SUBJECT: FINAL ENVIRONMENTAL ASSESSMENT
MILL STREET RETAINING WALL
JOB NO. 94-11

Final Environmental Assessment

Mill Street Retaining Wall

Figure 3 Mill Street Retaining Wall
 Section of Vertical Concrete Wall
 Next to Property Line

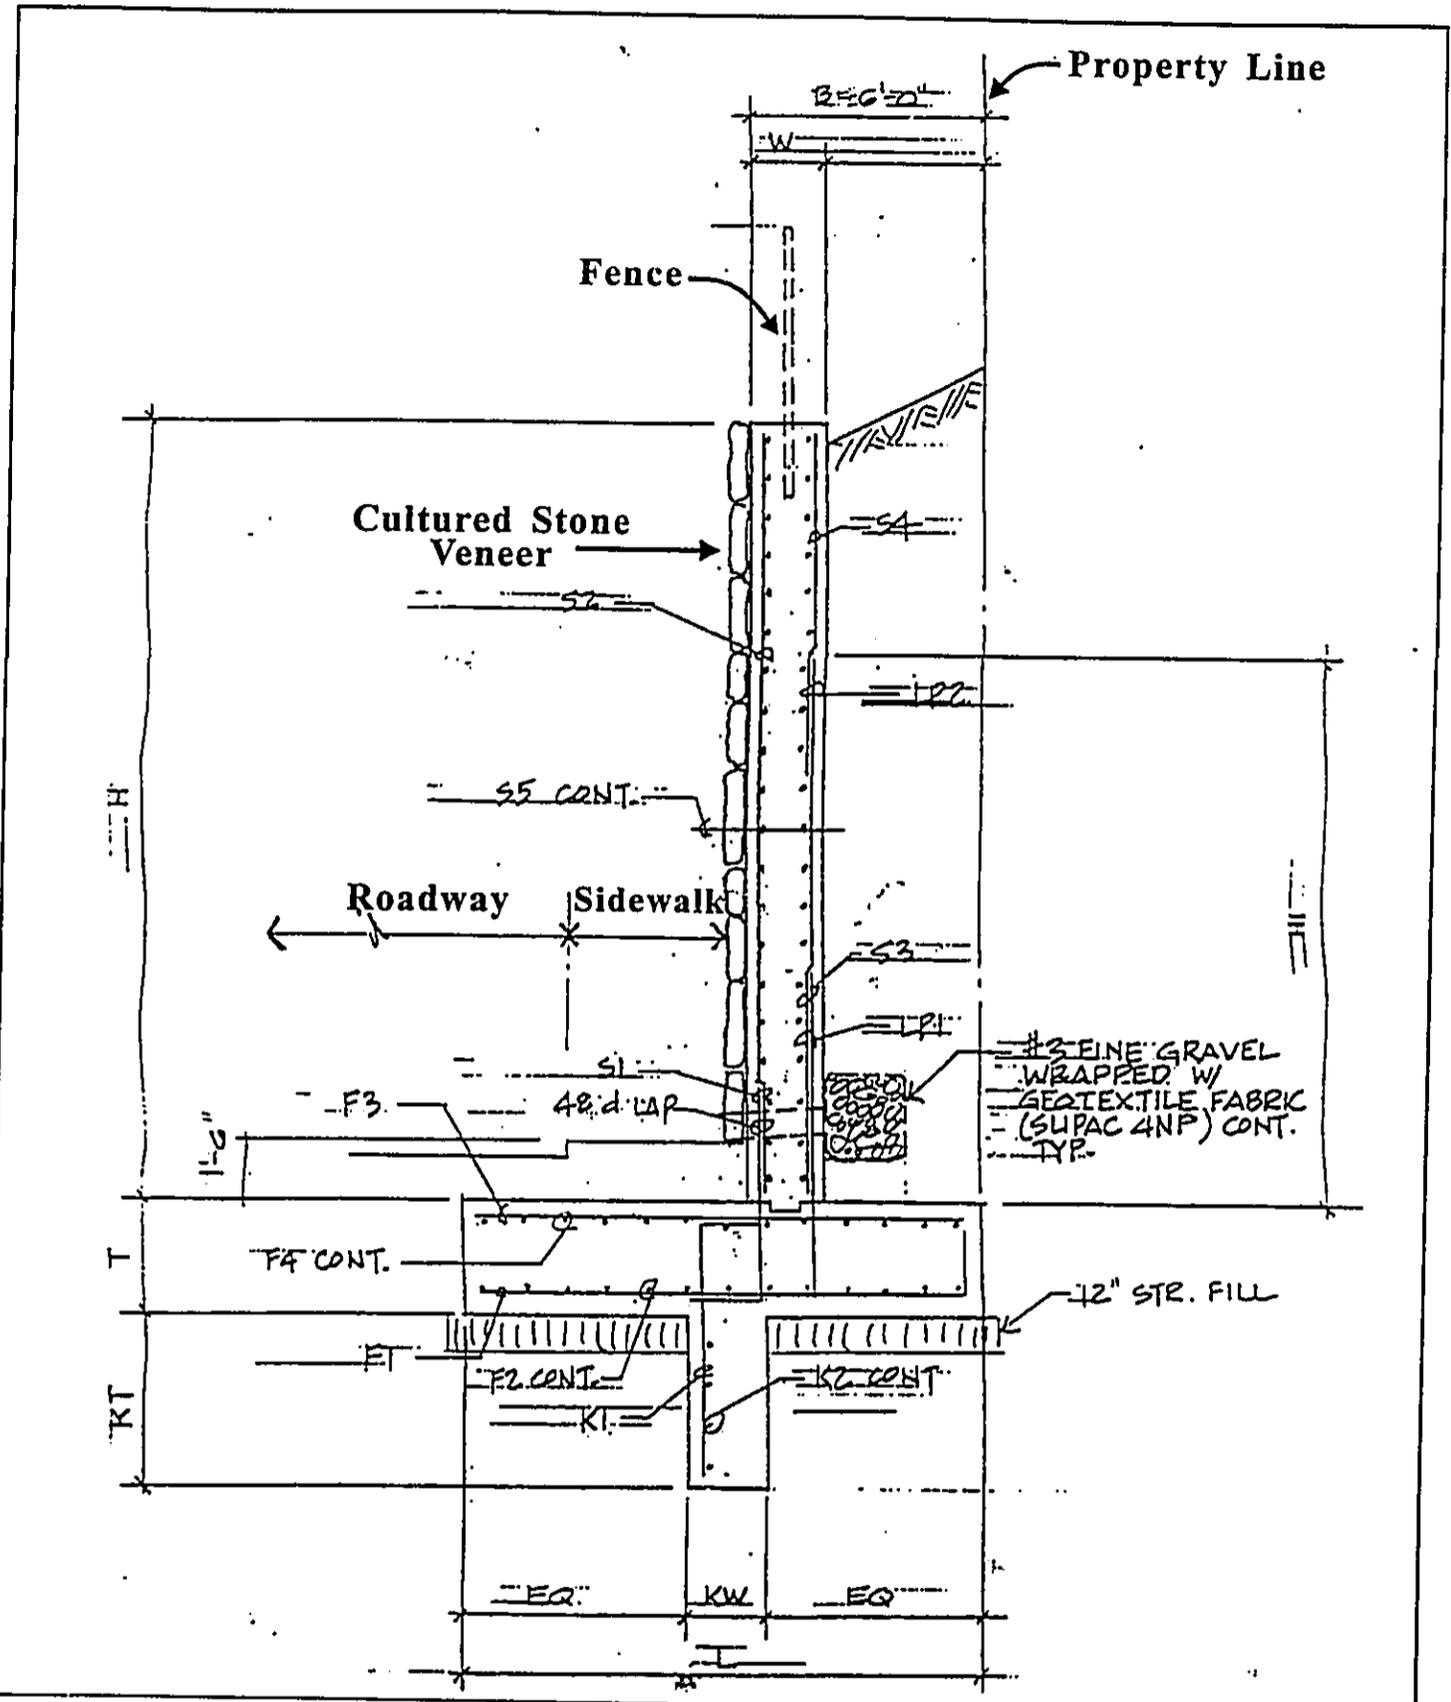
Please refer to page 4, figure 3.

If this wall is 14-22 feet in height, it needs to have aesthetically a 1:12 batter and at least a provision for planting from below or above to reduce the scale of the wall. We suggest plant material to cascade from above or to grow up from below i.e., fig ivy.

Additionally, the committee recommends that the rock veneer match the existing rock appearance. We further recommend as a safety precaution, that drainage be diverted into a planter rather than crossing the sidewalk. For example, roadway, sidewalk, planter then wall.

We appreciate your concern on landscaping around the project area. However, should the wall be constructed closer to the existing homes to create a landscape strip adjacent to the sidewalk, we have the same construction and cost concerns as the creation of a batter wall. Also, we are planning to match the existing low stone wall on Mill Street near the Market Street and Central Avenue intersections. The existing wall segments abut the sidewalk. Thus, the implementation of a landscape strip would not be continuous for this segment of Mill Street. We would also like to note that existing drainage patterns are not being altered by the project.

The possibility of landscaping from above to reduce the scale of the wall also poses a concern to us. Maintenance of the landscaping would be problematic since access is limited. The only access to a landscape strip would have to be through private property.

We are planning to place a rock veneer on the face of the wall to match, as closely as possible, the existing wall sections. It is anticipated that the rock veneer would maintain the look and feel of the original material.

PLAN & PROFILE - 1

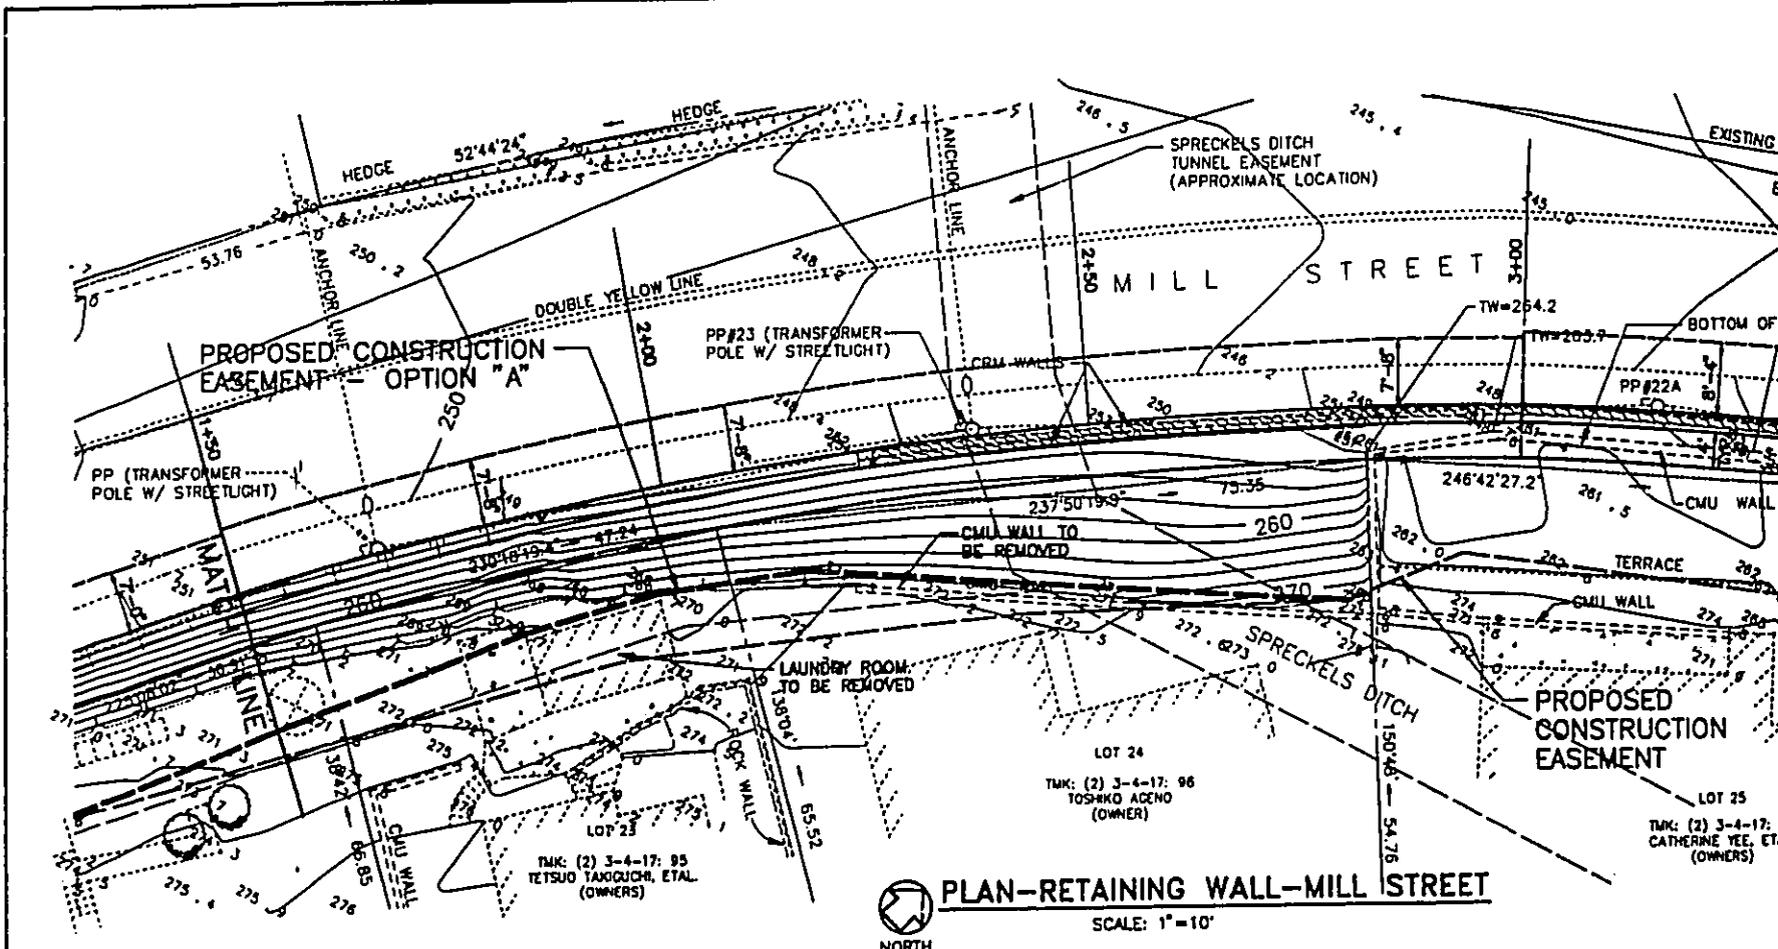
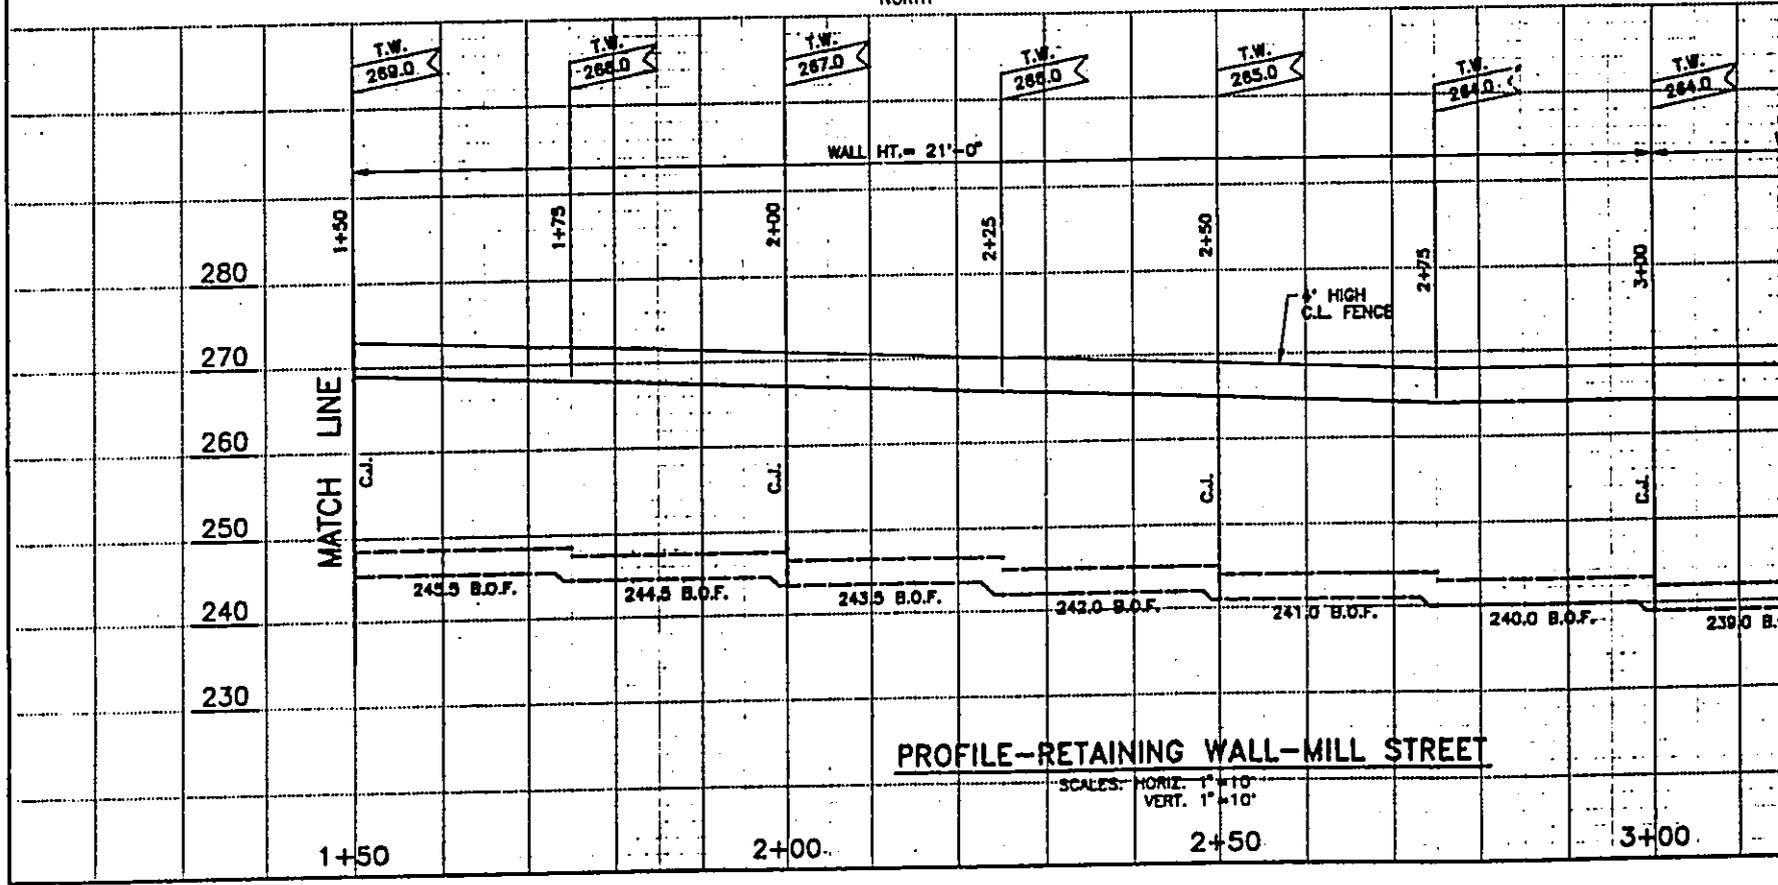
1. The Draft EA should provide more details and diagrams to
evaluate present and future earth movement in the area.
Please provide a preliminary plan and profile sketches
showing: a) present earth movement and surface and sub-surface
drainage patterns; b) proposed retaining wall and fill; and c)
future drainage patterns after the improvements. The drawings
must show the location of the wall in relation to existing
features.
2. Please provide a photograph of the stone veneer that will be
placed on the face of the retaining wall.

1. Pursuant to your comments, we will provide the enclosed plan and profile sheets as part of the final environmental assessment. We would like to note that the original retaining wall lasted approximately 40 years before portions of it fell in 1978. The new wall is proposed to be built in approximately the same location as the former wall and will not alter existing drainage patterns. The attached sheets also show the location of the wall in relation to existing features.
2. Attached is a color reproduction of the stone veneer intended to be utilized on the face of the wall. This would be a natural stone replica which should look and feel very similar to the original cut stone wall.
